UNITED STATES
NUCLEAR REGULATORY COMMISSION
WASHINGTON, D.C. 20555-0001

SAFETY EVALUATION BY THE OFFICE OF NUCLEAR REACTOR REGULATION

SUPPORTING AMENDMENT NO. 31 TO

THE MASSACHUSETTS INSTITUTE OF TECHNOLOGY

Figure 13 Fission Converter Water Shutter System

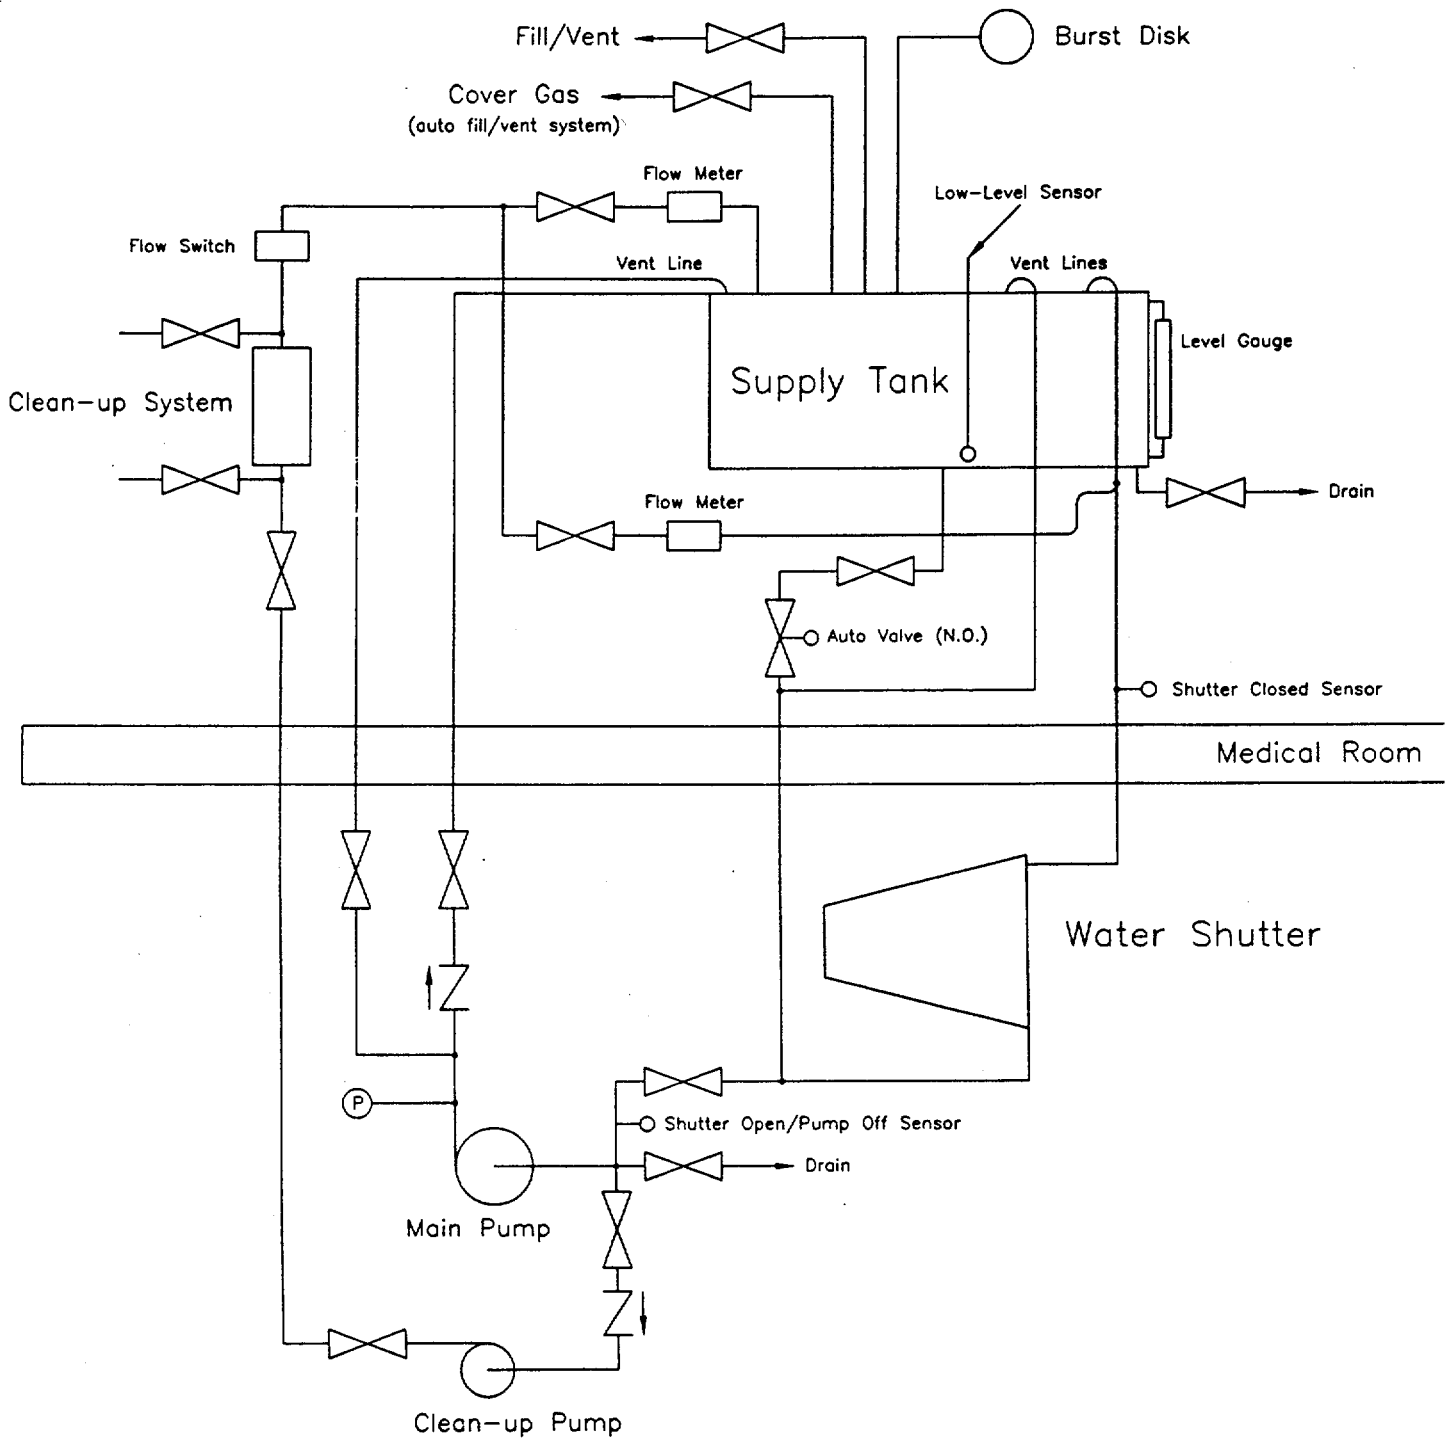
The water shutter is located in the collimator and provides neutron and gamma ray attenuation. Figure 13 presents a schematic of the water shutter control system.

The water shutter is one of three redundant shutters that "stop" the beam. This shutter closes (floods) by gravity with loss of off site power. The staff concludes that the water shutter is not reactor safety significant and will not have a significant reactivity effect on the reactor. The staff finds that the proposed water shutter design is acceptable.
